RAI 03.07.02-24, Supplement 1, Revision 1**QUESTION:****Follow-up Question to RAI 03.07.02-15 (STP-NRC-100036)**

RAI 03.08.01-9, Revision 2**QUESTION:****Follow-up to Question 03.08.01-6**

RAI 03.08.04-17, Supplement 1**QUESTION:****Follow-up to Question 03.08.04-1 (RAI 2964)**

RAI 03.08.04-28, Revision 1**QUESTION:****Follow-up to Question 03.08.04-19**

Figure 3H.6-44: Dynamic At-Rest Lateral Earth Pressure Diagrams (Excluding SSI and SSSI Seismic Soil Pressures) for Typical Section of RSW Tunnel

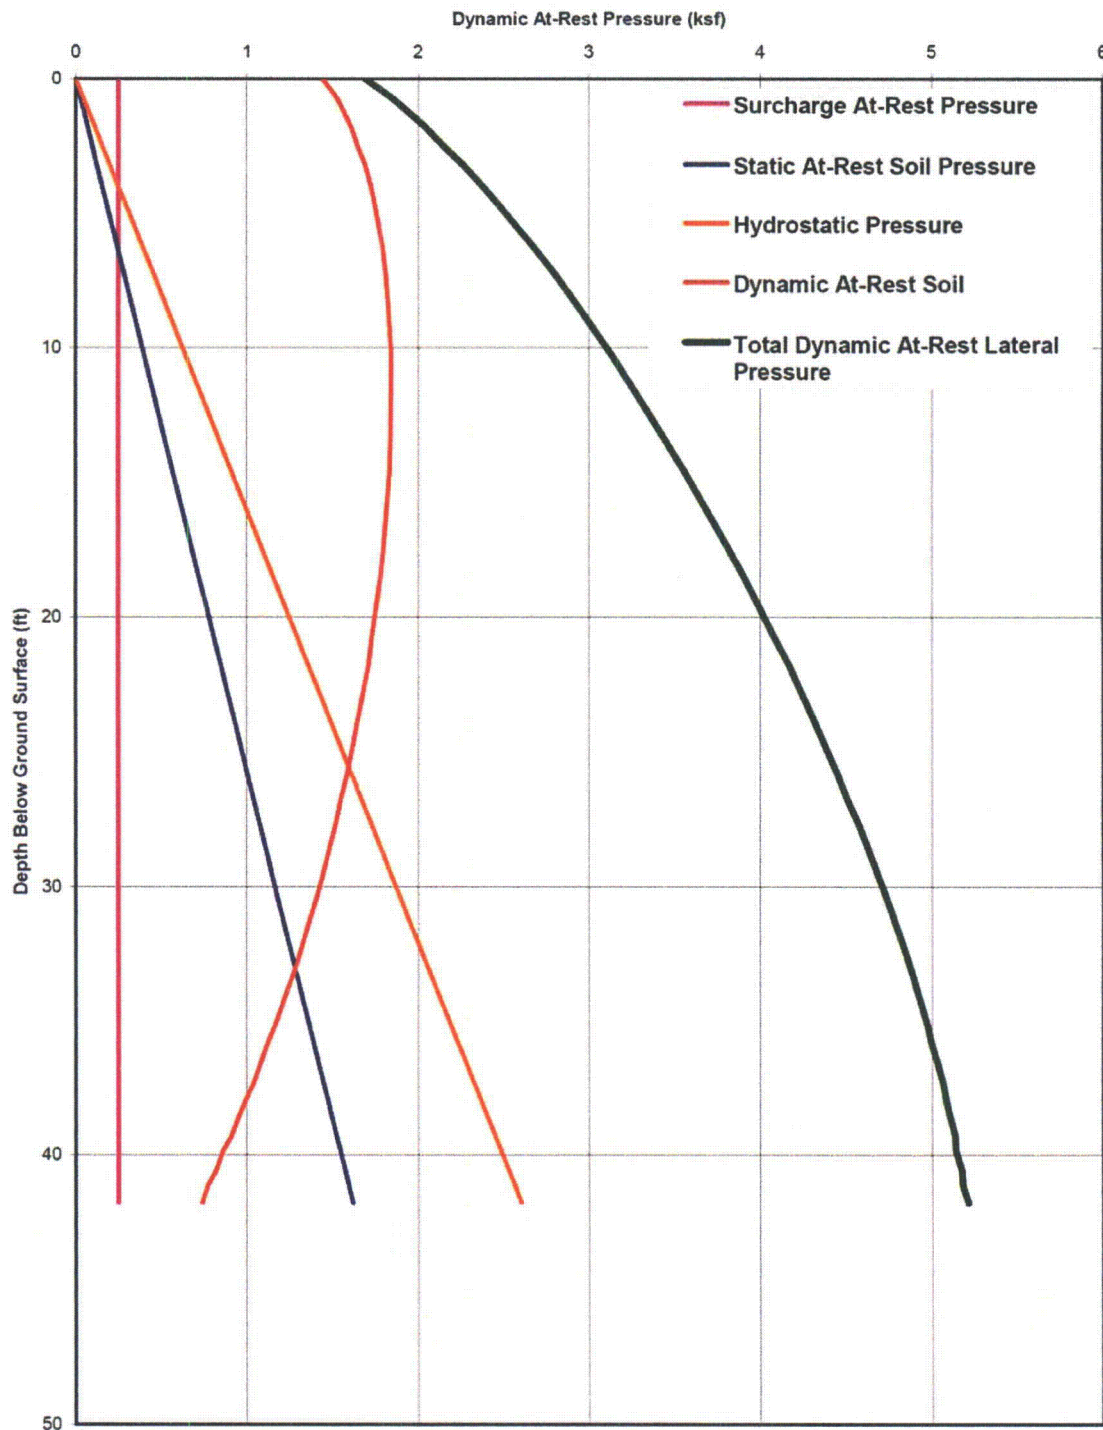
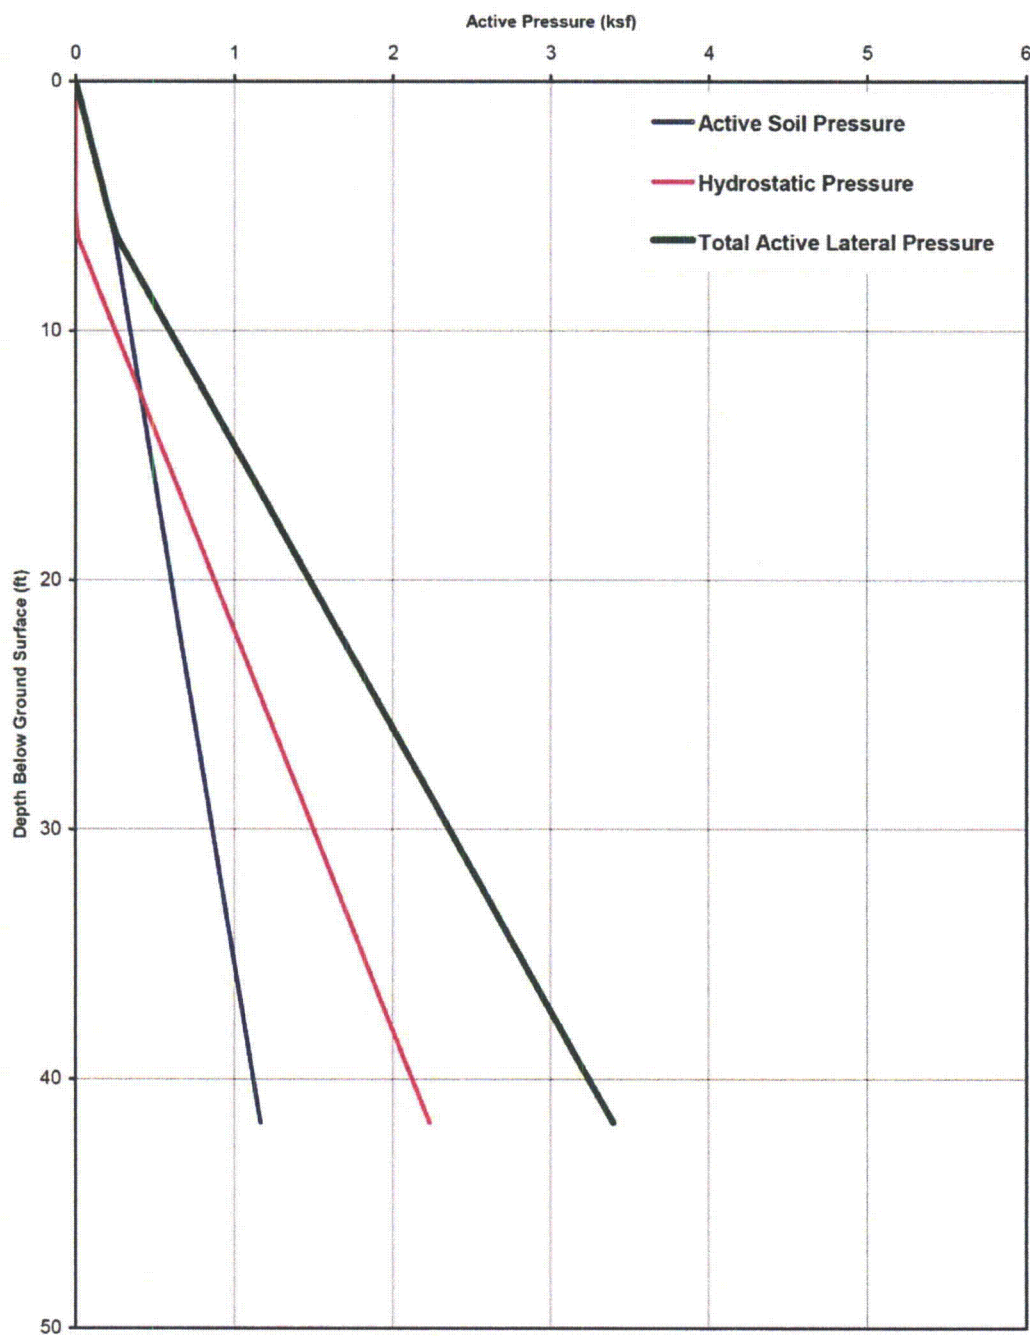
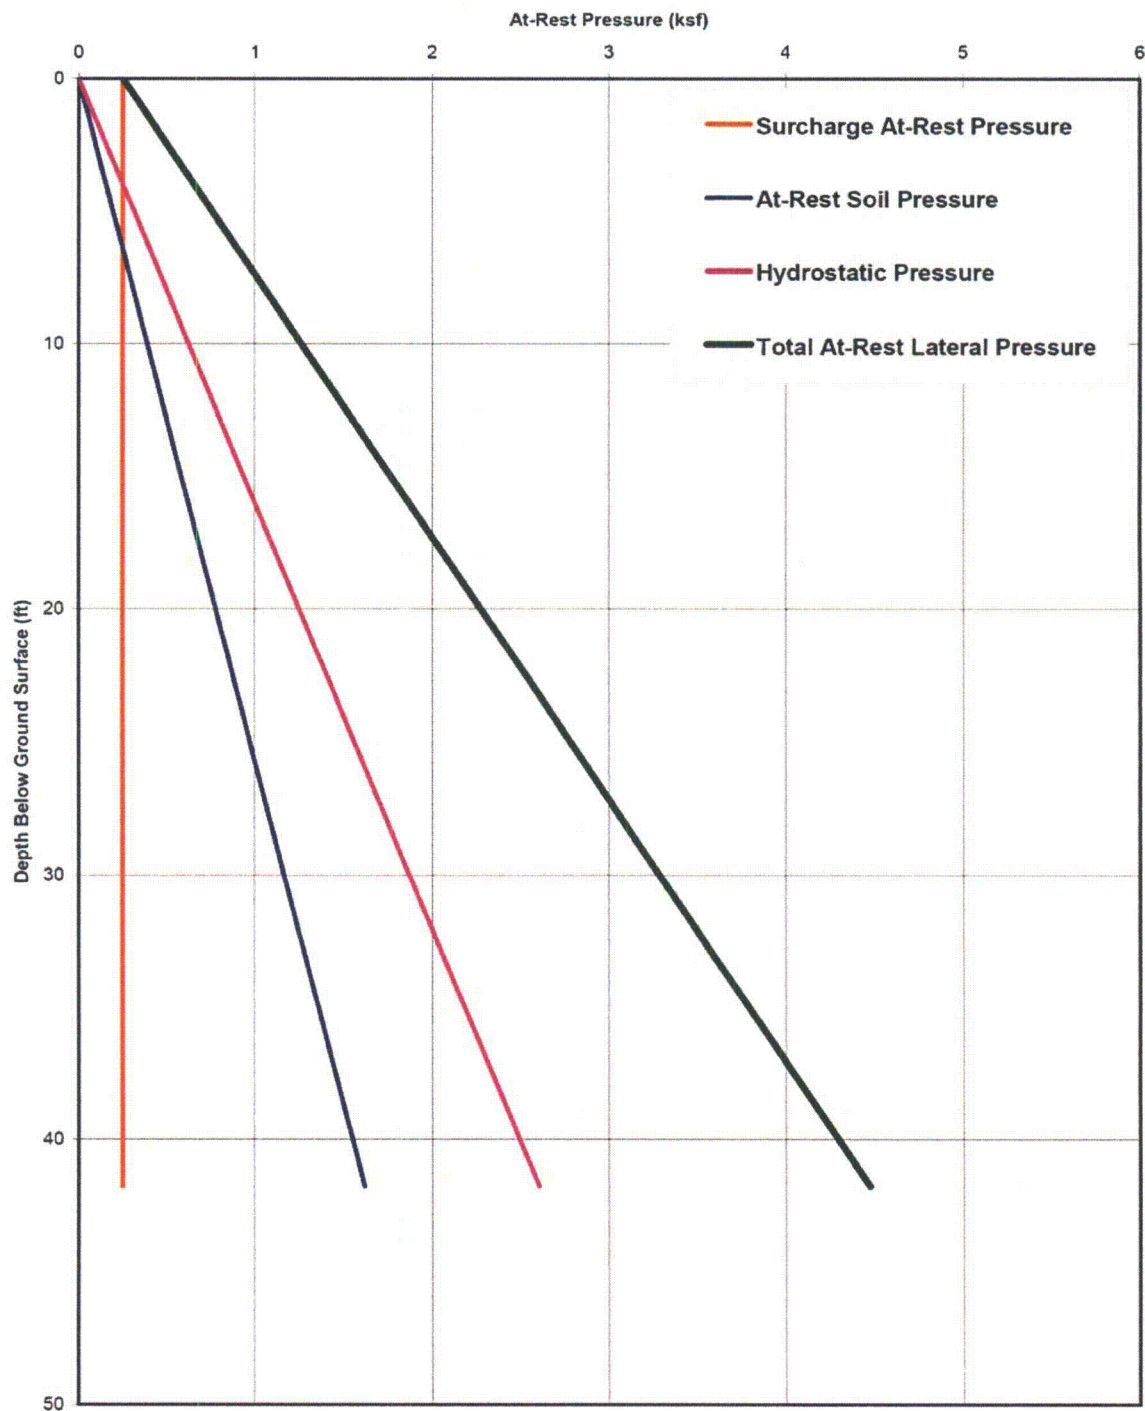
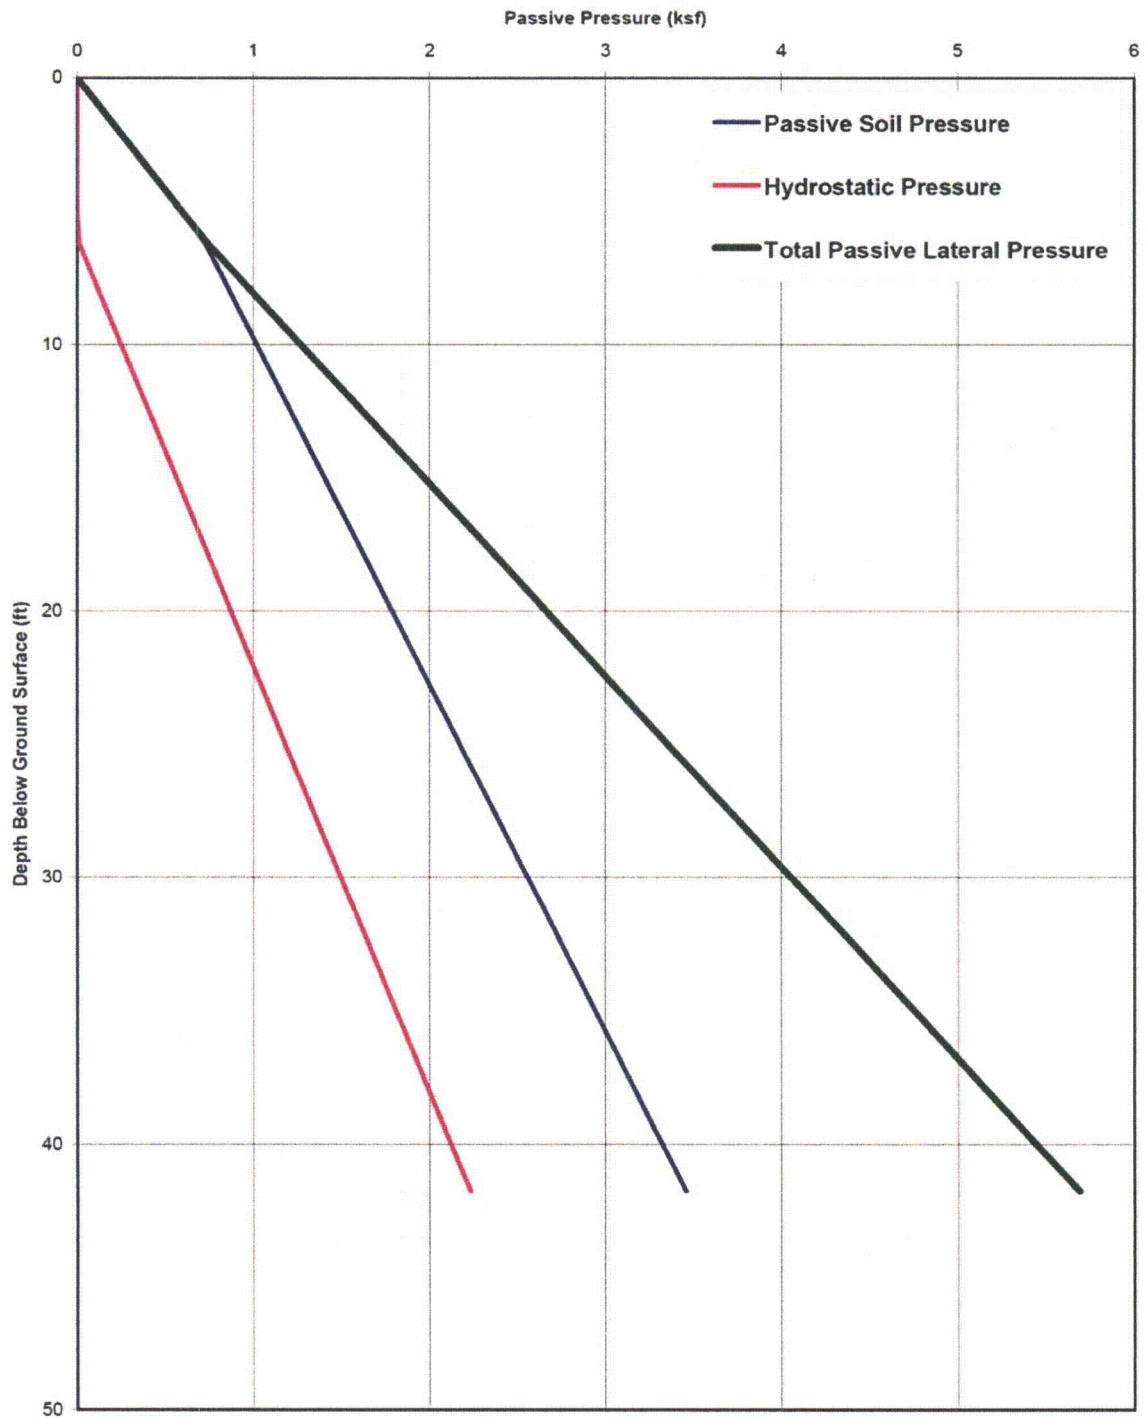
- b) For the staff to conclude that the design of structures with deep foundations, such as the Reactor Building (RB) and Control Building (CB), is satisfactory for the site, the site-specific design loads are needed to compare with the design loads used for the DCD. Lateral soil pressure is one such load. Therefore, please provide the lateral soil pressures for the RB and the CB, and compare these calculated pressures with those used in the ABWR standard plant design. Please also confirm if the effects of adjacent structures are considered in computing the lateral soil pressures, and if not, provide the justification for not doing so.

The SSSI incremental seismic soil pressure curves for the Reactor Service Water (RSW) Tunnel have been provided in COLA Part 2, Tier 2, Figures 3H.6-212 through 3H.6-217, in the response to RAI 03.07.02-24, Supplement 1, Revision 1, which is being submitted concurrently with this response. The at-rest, dynamic at-rest, active, and passive soil pressure profiles are provided in Figures 3H.6-44, and 3H.6-245 through 3H.6-247, included in Enclosure 1 of this response.
